Title - Sujet Reconst. Manège militaire Québec	
Solicitation No. - N° de l'invitation EE520-151410/B	Amendment No. - N° modif. 013
Client Reference No. - N° de référence du client EE520-151410	Date 2015-02-26
GETS Reference No. - N° de référence de SEAG PW-\$QCM-009-16291	
File No. - N° de dossier QCM-4-37219 (009)	CCC No./N° CCC - FMS No./N° VME
Solicitation Closes - L'invitation prend fin at - à 02:00 PM on - le 2015-03-12	
F.O.B. - F.A.B. Plant-Usine: <input type="checkbox"/> Destination: <input checked="" type="checkbox"/> Other-Autre: <input type="checkbox"/>	
Address Enquiries to: - Adresser toutes questions à: Thellend, François	Buyer Id - Id de l'acheteur qcm009
Telephone No. - N° de téléphone (418) 649-2889 ()	FAX No. - N° de FAX (418) 648-2209
Destination - of Goods, Services, and Construction: Destination - des biens, services et construction:

AMENDMENT 013

1) Questions and answers #383 to 452.

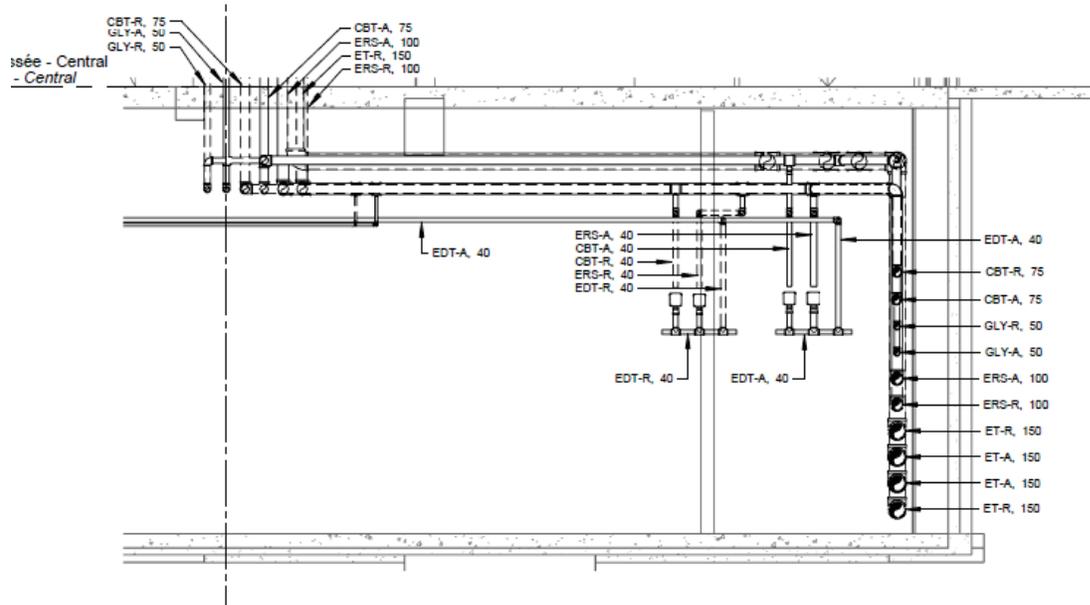
We would like to better understand the dual temperature water system. When we look at the two 40mm manifolds, there are 4 accessories. Are these valves, temperature gauges? Nothing is indicated in the Legend. Please clarify.

In addition, would it be possible to have a larger cross-section to get a better view of the piping in this section?

Refer to drawing M-351.
